**APPLICANT'S
RESPONSE TO
INTERESTED
PARTIES'
DEADLINE 3
SUBMISSIONS: 9.23**

Cory Decarbonisation Project

PINS Reference: EN010128

FEBRUARY 2025

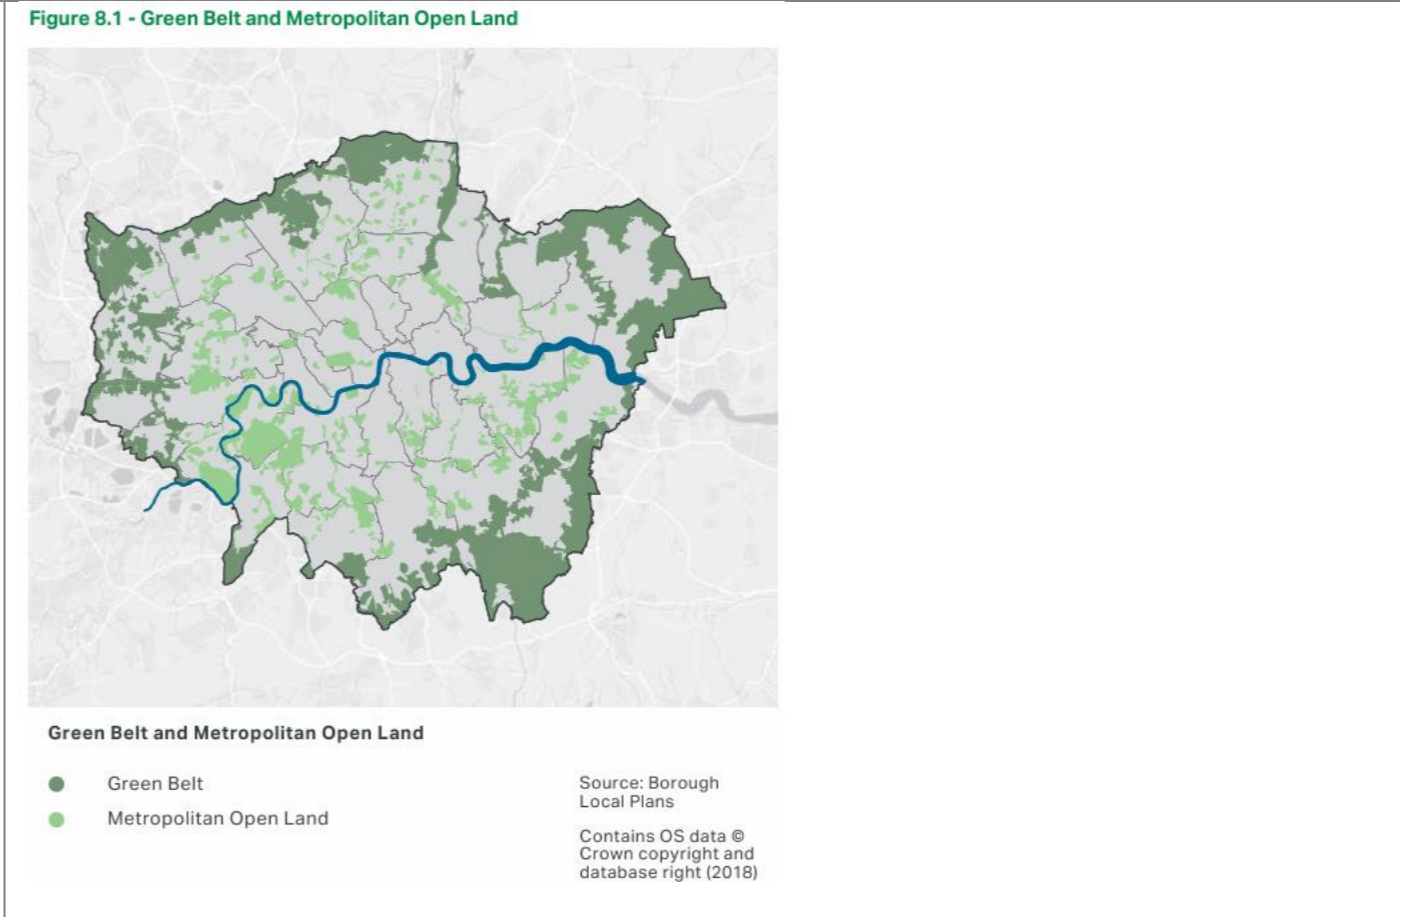
2.9.8	<p>The Applicant’s response confirms that it is feasible to have a longer gas flue pipe to an alternative site further away that is not in MOL or part of a Nature Reserve. TWUL considers that the primary reason that a longer pipe has not been selected is because it would cost more.</p> <p>TWUL has consistently taken the position, since the pre-application process, that the Applicant’s site selection process was not robust and that more sites that are not in MOL or part of a Nature Reserve should have been assessed. It is the Applicant’s responsibility to undertake a robust site selection process prior to submitting their application; TWUL considers that this has not been undertaken</p> <p>With regards flood risk designation, Veridion Business Park has the same flood risk designation as the surrounding area, including the Applicant’s preferred site:</p>	<p>As set out in the row above, the Applicant has comprehensively responded to TWUL’s assertions previously and this submission does not raise new points.</p> <p>On pages 101 and 102 of its Response to Interested Parties Deadline 1 Submissions (REP2-019), the Applicant directly addresses TWUL’s promotion of Veridion Park. The Applicant confirms that Veridion Park is not a reasonable alternative, a matter agreed with LBB (see SoCG Rev C, AS-080). Further, the Applicant refers to NPS EN-1 paragraphs 4.3.27 and 4.3.28 which advise that alternative proposals that mean the development could not proceed because they are not commercially viable or physically suitable, and those that are vague or immature, can be excluded on the grounds that they are not important and relevant to the Secretary of State’s decision. This is clearly the case for the Veridion Park proposal given the constraints discussed in REP2-019.</p>
